# SERVICE BULLETIN

Service Bulletin No.: DA20-56-1, Rev. 0

Title: Canopy, Side Window Water Drain

Figure 1a.

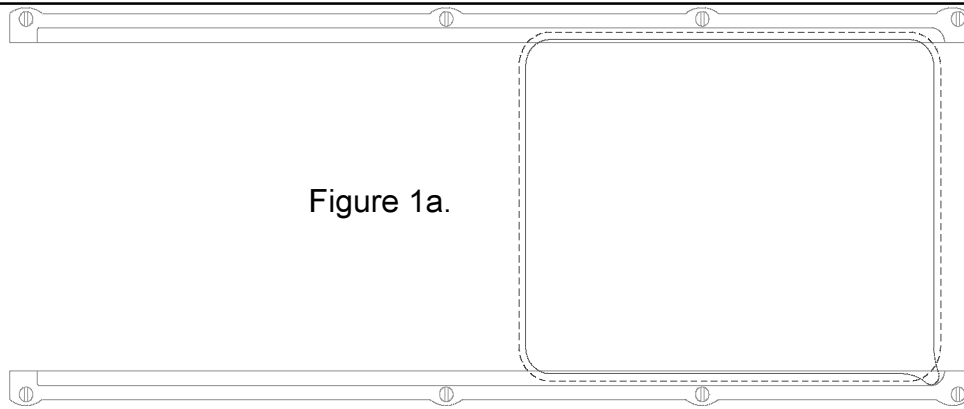
9. **References:** DA 20 Katana Maintenance Manual Doc. No. DA201
10. **Accomplishment Instructions:**
- 10.1 Determine the trough style installed on the aircraft, either Figure 1a or 1b.

10.3 If the window style shown in Figure 1a then the modification is as per Figure 3. A template of the router fixture is depicted in Figure 9, page 6 which locates on the two forward trough screws. Fashion a routing template based on the attached drawing. Locate the the template on the two forward screws and using a 1/16" or 1/8" tapered router bit route the canopy as shown in Figure 3 using the template as a guide. Carefully remove any sharp edges with a small round file.

Figure 1b.

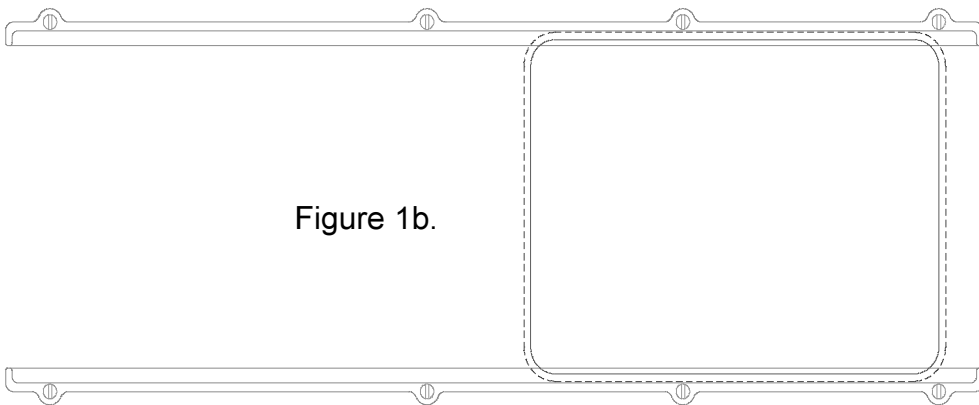
- 10.2 If the style shown in Figure 1b is installed, a 6mm (ref 15/64") drill will need to be dressed as shown in Figure 2a. The hole is to be located as shown in Figure 2b.

Figure 2a.

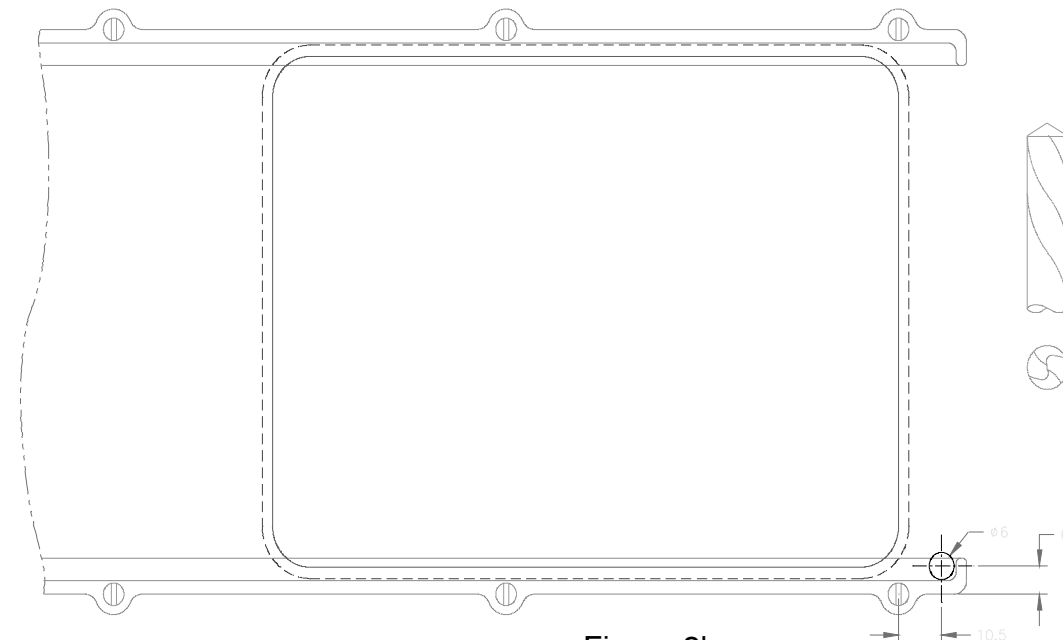
**CAUTION:** It is **very important** to remember that when drilling the acrylic:
    - (a) the drill must be dressed as shown in Figure 3 and,
    - (b) to press lightly all the way through. Let the dressed drill melt/cut its way through the acrylic. Carefully remove any sharp edges with a small round file.

Figure 6.

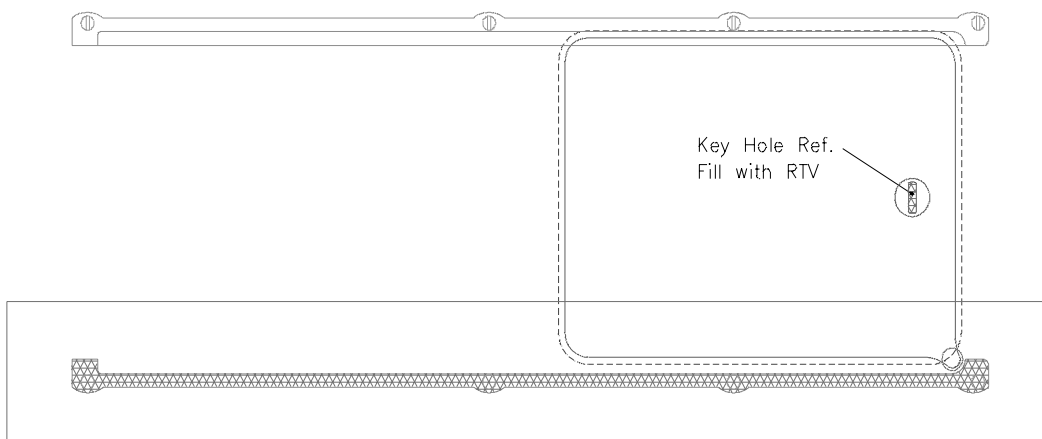
- 10.6 Apply a bead of RTV 108 to the exposed likeness of the trough (Figure 6) on the canopy. Fill the locking mechanism hole in the knob of the sliding window. Use only as much as required to keep the next steps from being messy.

Figure 8.

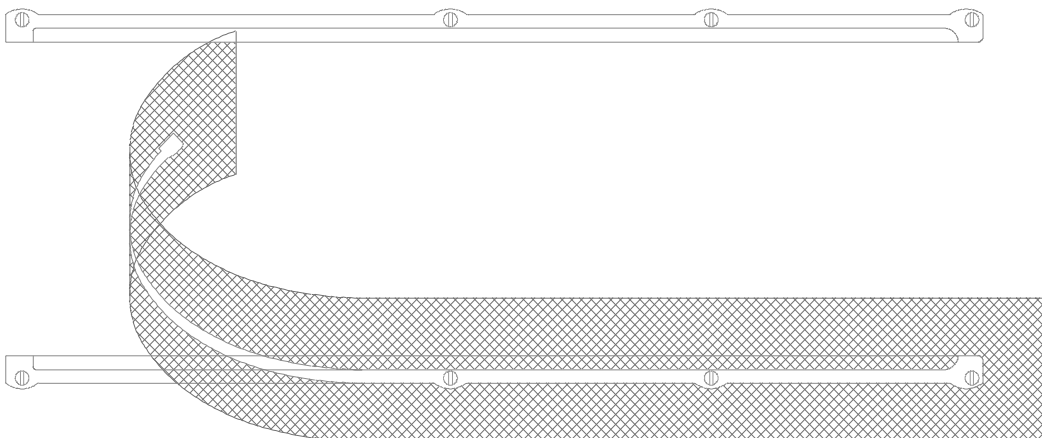
- 10.8 After the RTV is no longer tacky, remove the rest of the tape as shown in Figure 8. Remove the upper trough and reinstall the sliding window. Allow the RTV to cure before exposing to moisture.
